# *SERVICE BULLETIN*

PN: 21220076

**MODEL:** NewLife Elite, Intensity 10 and VisionAire 5

**ISSUE:** IEC 80601-2-69 Oxygen Concentrator Particular Standard Compliance

**Previous VisionAire Alarm Panel**

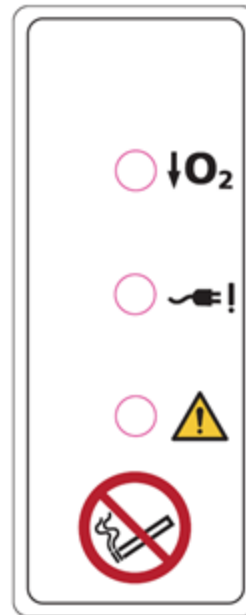
## Major changes on updated design VisionAire

- Additional alarm lights than previous model
- Updated warning symbols on label
- New plastic switch cover for button panel
- New circuit board
- New cover over circuit board
- Ferrite ring for incoming AC power
- Heat shrink tubing on the circuit breaker, power switch, and hour meter
